ADDENDUM FOUR

CITY OF PHARR

PHARR NEW AQUATIC CENTER

ADDENDUM #4

DRAWN:	LEDUCCAD
CHECKED:	H.LEDUC
JOB NO.	1160
DATE:	04/03/12
DRAWING NO.	P101

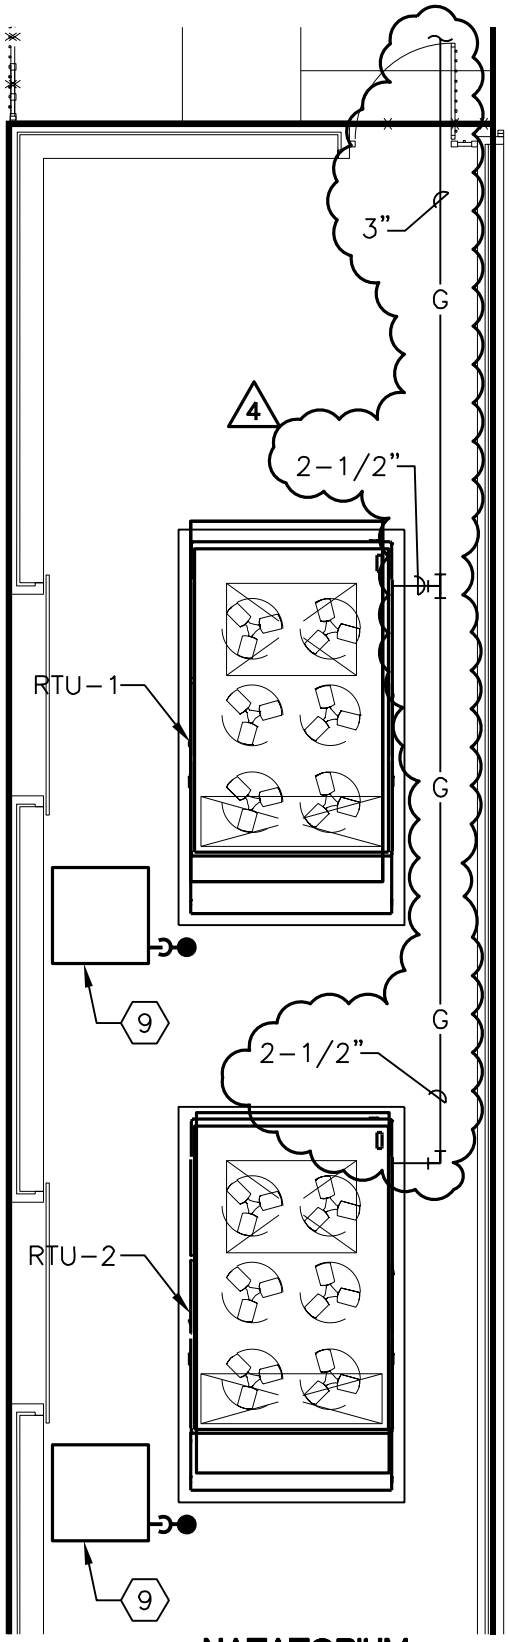
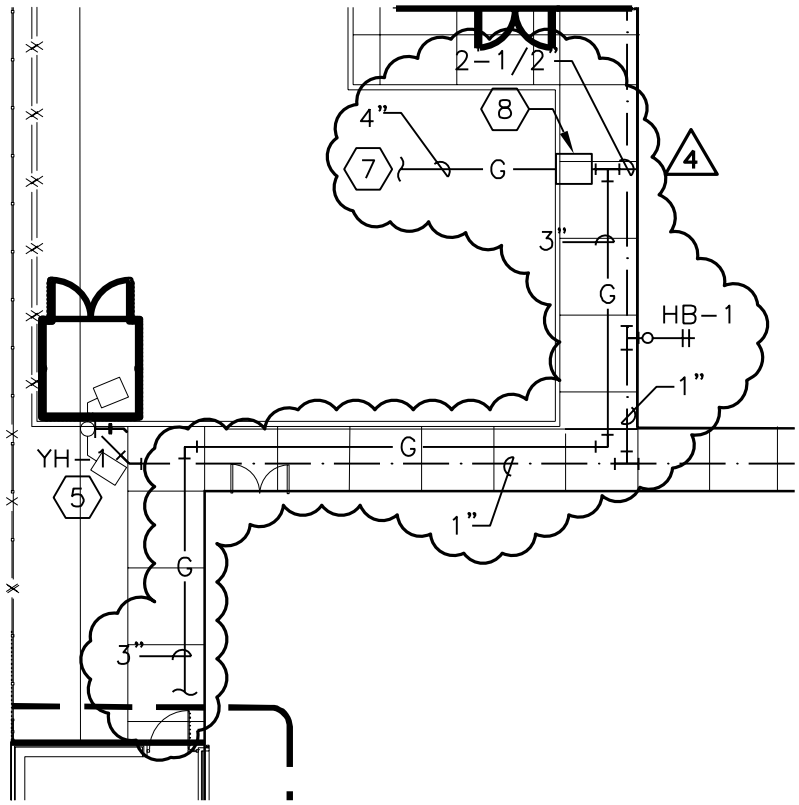
1. Modify packaged rooftop unit schedule to specify new Aon on RTU-1 and RTU-2 which include natural gas heating sheet M103.
2. Modify natural gas pipe size to supply Aon units on plans sheet P101 and on gas riser sheet P103.
3. Updated specification section 15736 "Packaged Rooftop Air Conditioning Units" to accommodate the new Aon units specify.
4. Updated specification section 16001 "MEP System Requirements".
